For 3M [™] C921BA Base Stations previous to serial number 0921012545

Instructions for Disabling the Monitor Level Reduction Circuit

C921BA Base Station

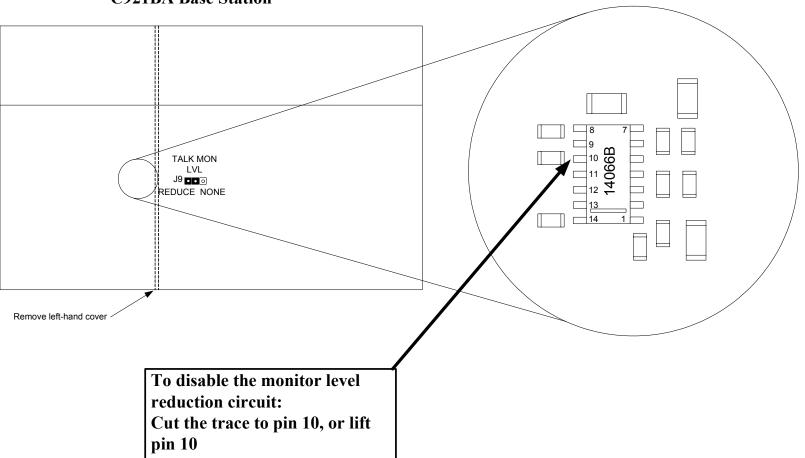
3M Wireless Base Stations beginning with serial number 0921012545, have a redesigned "TALK MON LVL" jumper J9. This jumper was previously labeled "REDUCE - NONE". It is now labeled "REDUCE - FULL".

- **REDUCE** With the left 2 pins jumpered, the monitor speaker volume will be reduced 16 dB when the Talk button is pressed. Note - This includes the time Talk/Lock operation is activated.
- **FULL** With the right 2 pins jumpered, the monitor speaker volume will not be affected. Note - This setting may cause feedback if the headset is operated near the monitor speaker.

Whenever a jumper setting is changed, the RESET SWITCH on the base station circuit board must be pressed to program the new jumper setting into the microprocessor. Also, each of the headsets in the system must be reprogrammed when a jumper setting is changed.
